## ADDENDUM NO. 1

**DATE: June 26, 2015**

Contract 14-C-00042; Melrose Pump Station Rehabilitation

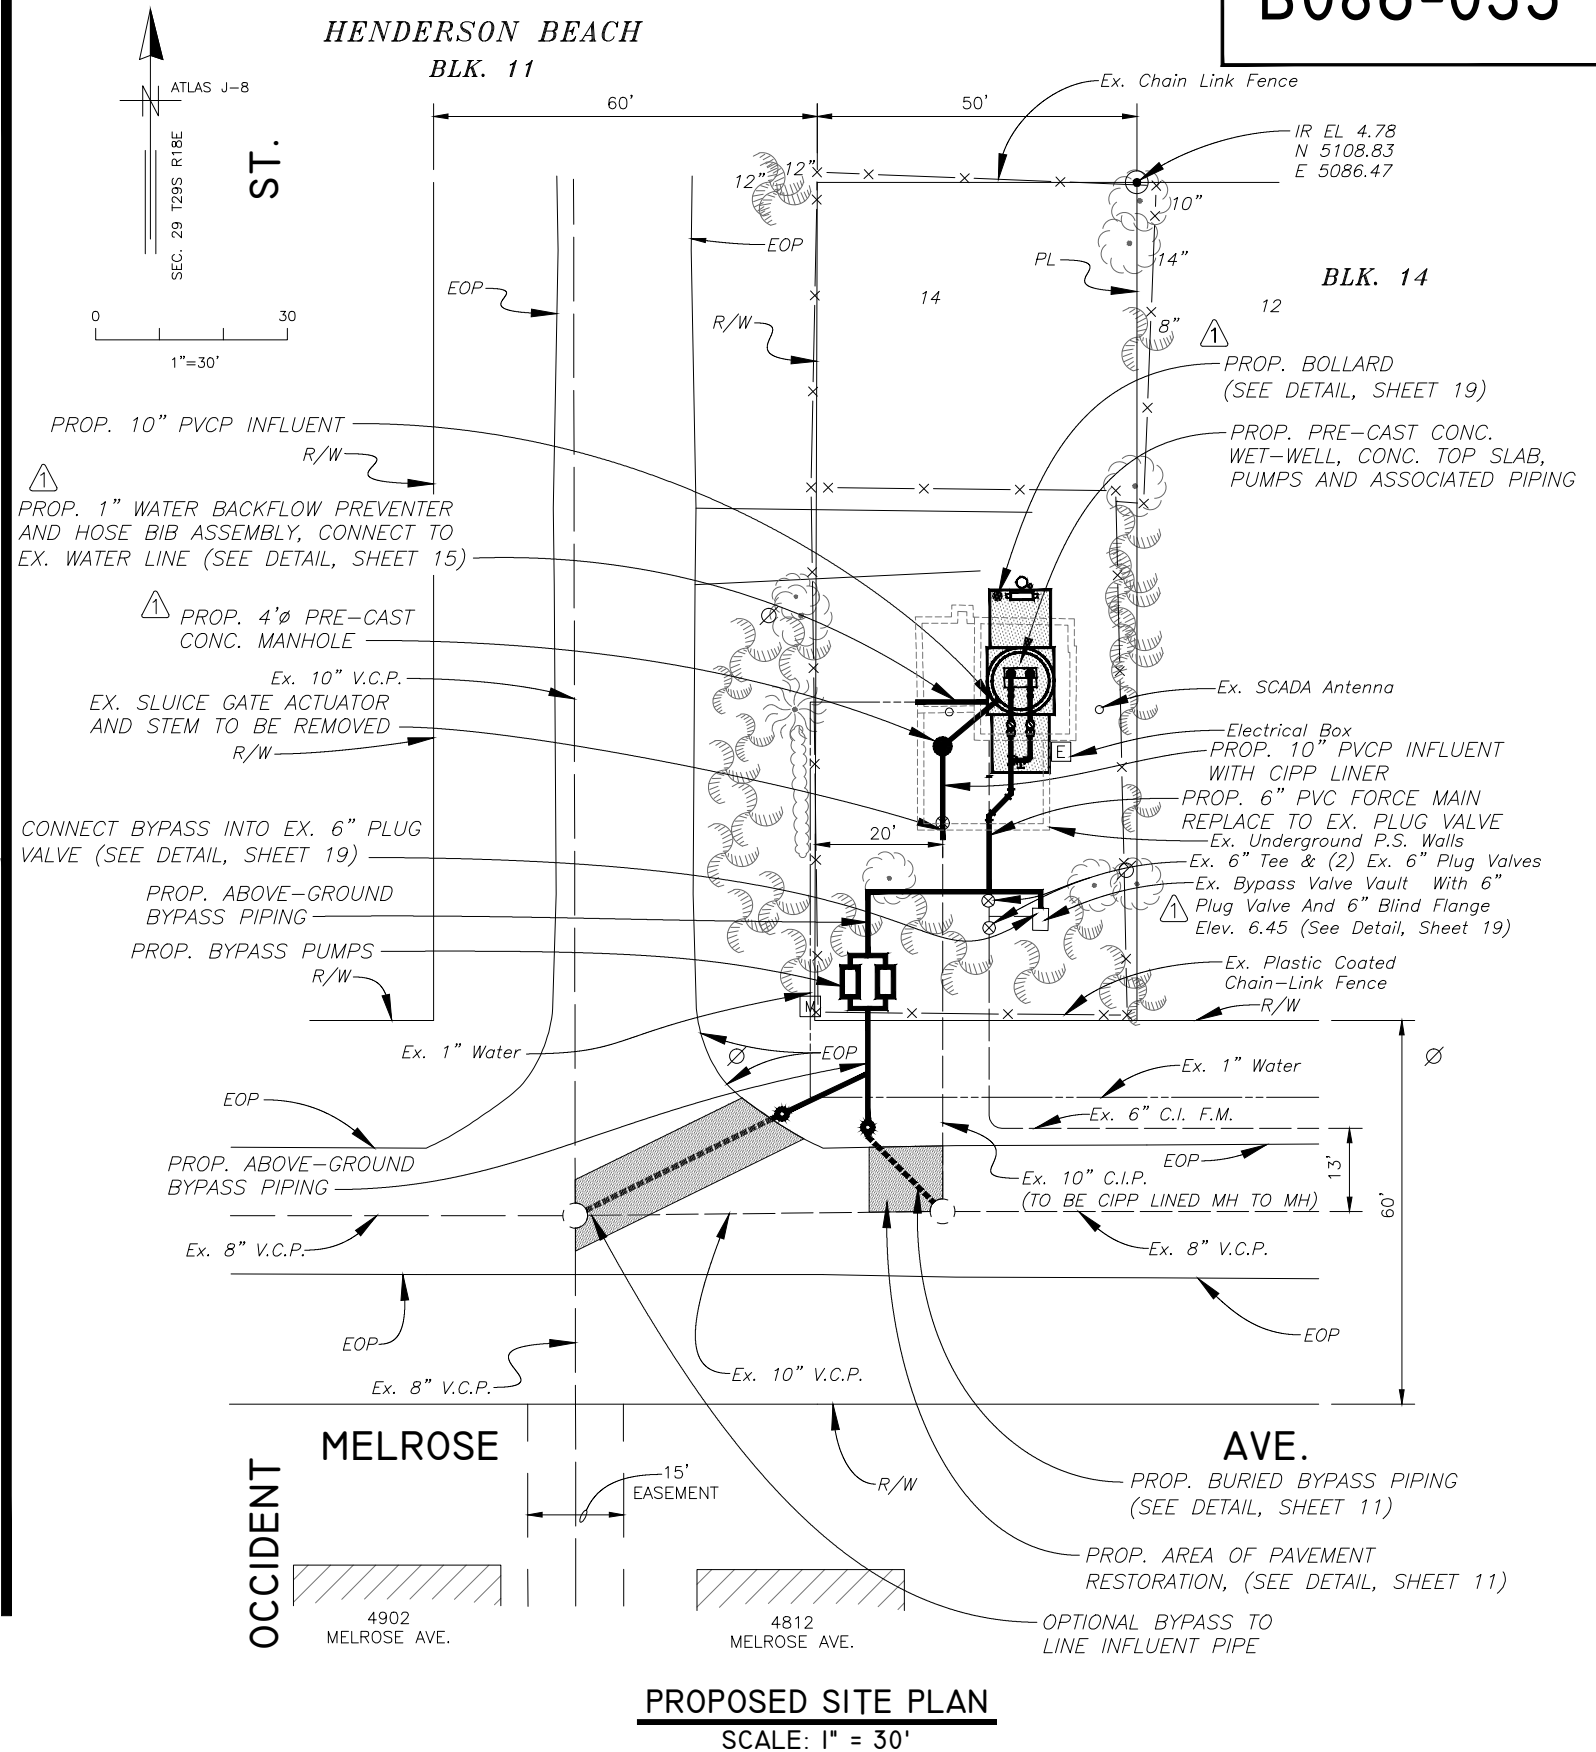
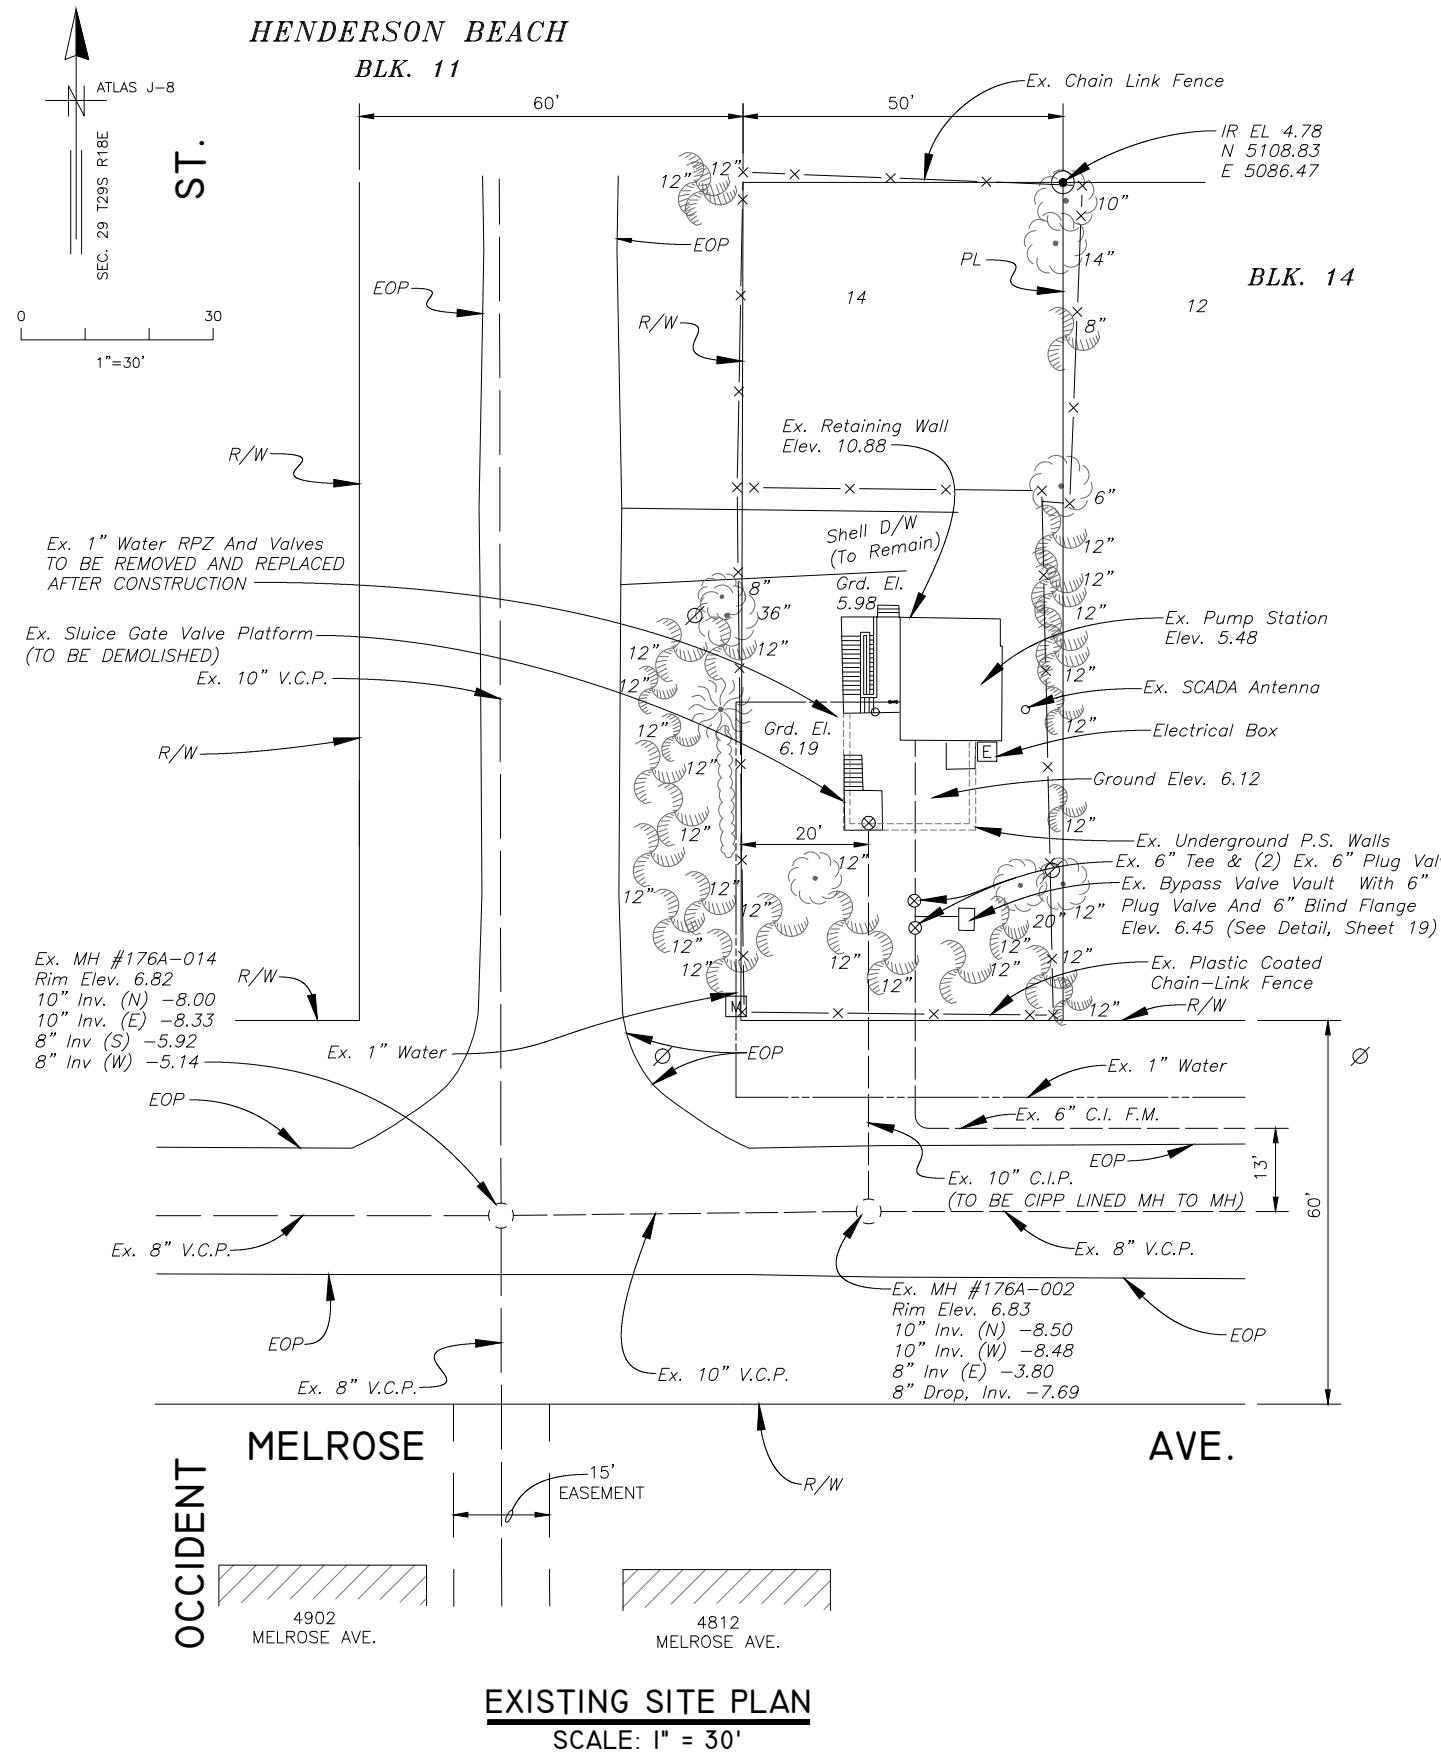
- ⚠ D-1. SALVAGEABLE MATERIAL, AS DETERMINED BY DEPARTMENT PERSONNEL, SHALL BE DELIVERED TO THE PARTS WAREHOUSE LOCATED ON THE TREATMENT PLANT SITE. NON-SALVAGEABLE MATERIALS ARE TO BE REMOVED FROM THE SITE AND PROPERLY DISPOSED OF AT THE CONTRACTOR'S EXPENSE. IN GENERAL, ALL PUMP AND CONTROLS EQUIPMENT SHALL REMAIN PROPERTY OF THE CITY AND BE CONSIDERED SALVAGEABLE.

- ⚠ D-5. THE CITY DOES NOT BELIEVE LEAD PAINT IS PRESENT IN THE BUILDING. PER EPC REQUIREMENTS, CONTRACTOR WILL BE REQUIRED TO PROCURE A THIRD PARTY LEAD PAINT SURVEY FROM A CERTIFIED LEAD PAINT INSPECTION CONSULTANT. DEMOLITION OF PUMP STATION BUILDING CANNOT BEGIN UNTIL (3) WEEKS AFTER THE LEAD PAINT SURVEY IS SUBMITTED TO THE ENGINEER. THE CITY WILL FURNISH EPC WITH THE REQUIRED NOTIFICATION. IF THE SURVEY DISCOVERS THE PRESENCE OF LEAD PAINT, THE CITY WILL UTILIZE CONTINGENCY FUNDS FOR THE LEAD PAINT REMOVAL IN ACCORDANCE WITH EPC STANDARDS.

- ⚠ G-26. PROPOSED PRECAST WET WELL SHALL BE CONSTRUCTED IN ACCORDANCE WITH ASTM C-76, CLASS II WALL B. MINIMUM STEEL REINFORCEMENT SHALL BE INNER CAGE .57 IN<sup>2</sup>/FT AND OUTER CAGE .34 IN<sup>2</sup>/FT. (SEE SPECIFICATIONS)

JACINTO CARLOS FERRAS, P.E. #49454 DESIGN DIVISION HEAD WASTEWATER DEPARTMENT	No.	DATE	REVISIONS	DES: CB	CITY of TAMPA WASTEWATER DEPARTMENT	MELROSE AVENUE PUMPING STATION REPLACEMENT GENERAL NOTES, DEMOLITION NOTES AND CONSTRUCTION SEQUENCE	W.O.1000061
	3			DRN: BB			SHEET
	2			CKD:			3
	⚠	06/26/15	ADDED NOTE D-5, REVISED NOTES D-1, G-26, G-29 & B-4	DATE:

MELROSE AVE. PUMPING STATION  
REPLACEMENT  
EXISTING AND PROPOSED SITE PLANS

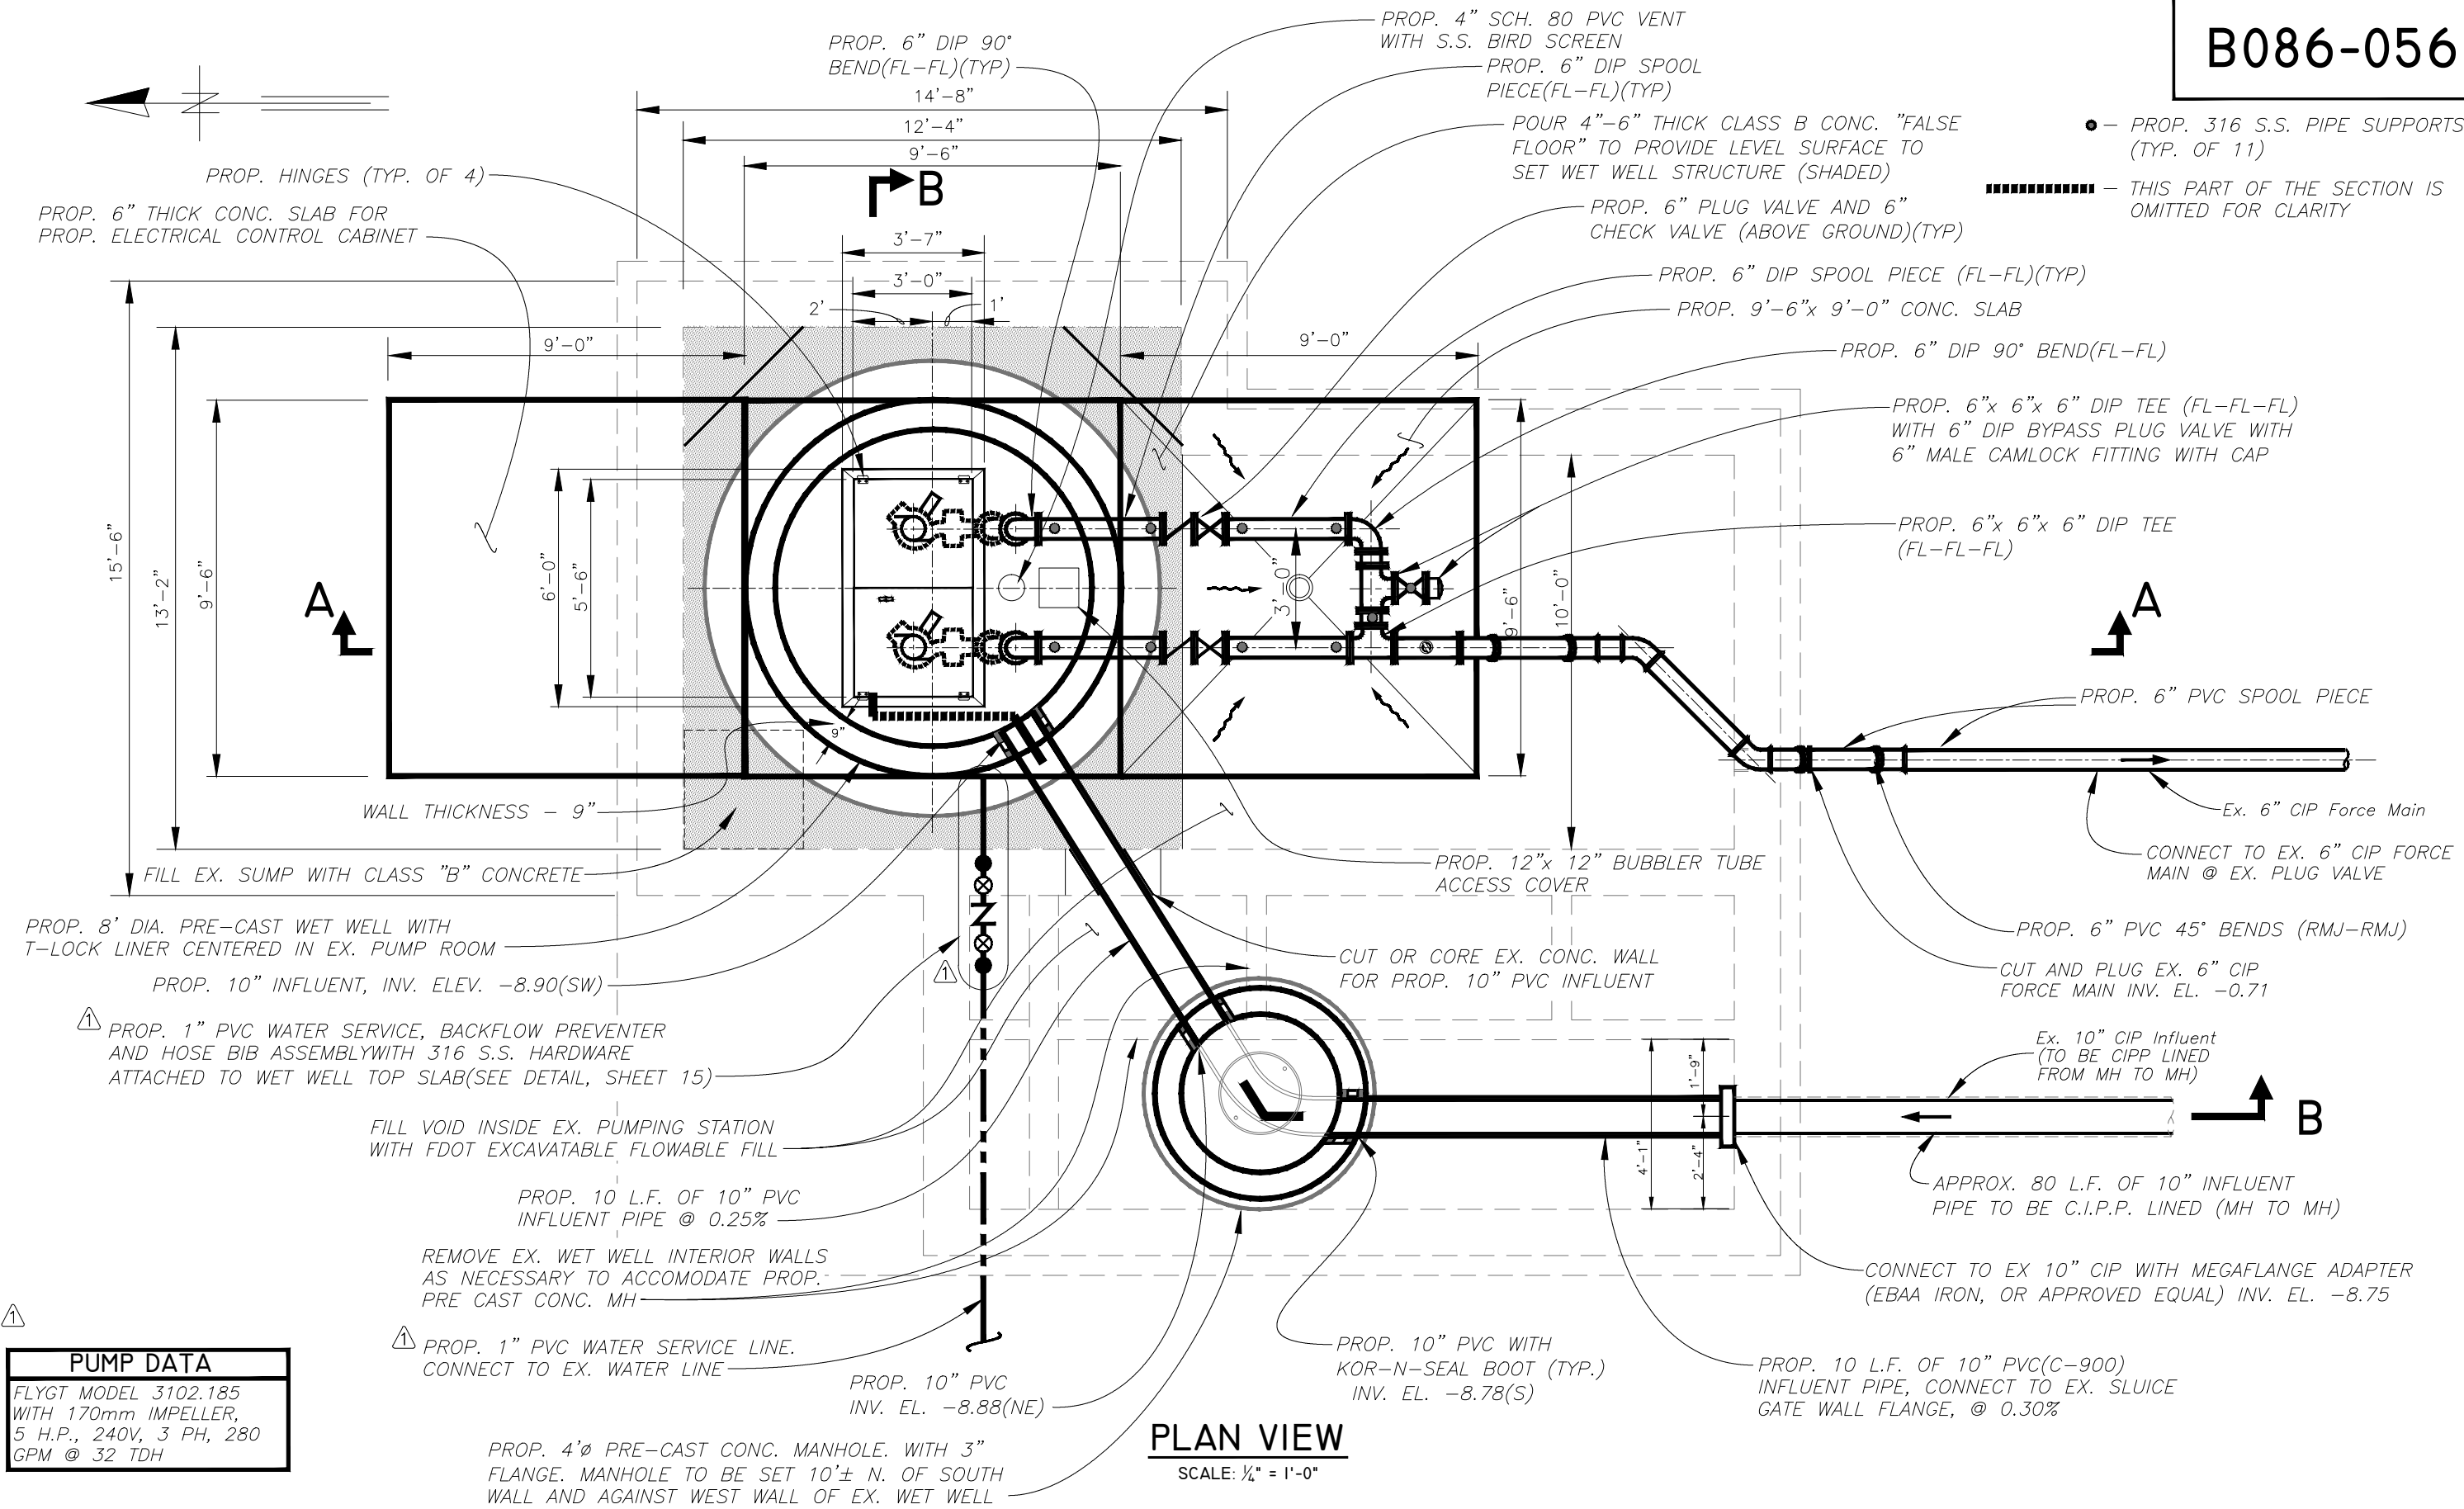
No.	DATE	REVISIONS
3		
2		
①	06/26/15	REVISED MANHOLE TYPE, WATER CONNECTION, AND BYPASS CONNECTION
